Access Compliance Report

Public Rights-of-Way

(Curb Ramps)

Intersection ID: 15375	Main Street: FUGATE_AV	Cross Street: MONROE_RD	Location: E
ADA ID: 3C5F727664BF	Ramp Type: Para	Initial Pass/Fail: Fail	Overall Compliance: No
Codes/Mitigation Info/Possible Solution		Field Measurements/Component Compliance	
Severity Score: 13.75

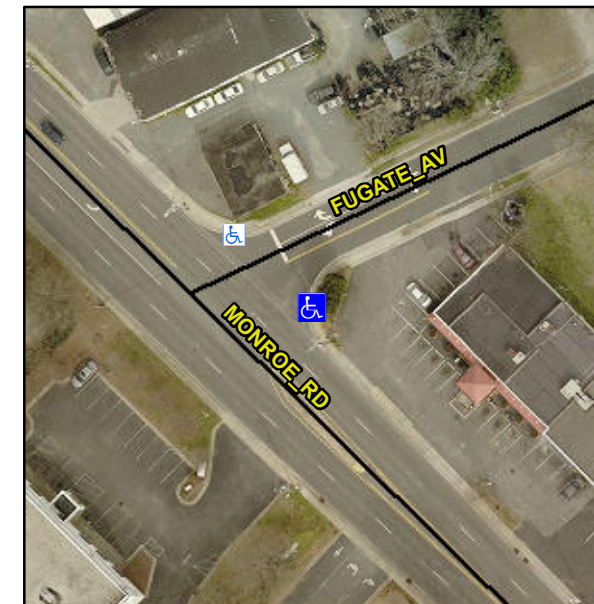
Surveyor Notes:

RT RP < 5%

PROW/ADA:

R304.3.2, R304.5.3

Possible Solutions:

Remove & Replace Entire Ramp.
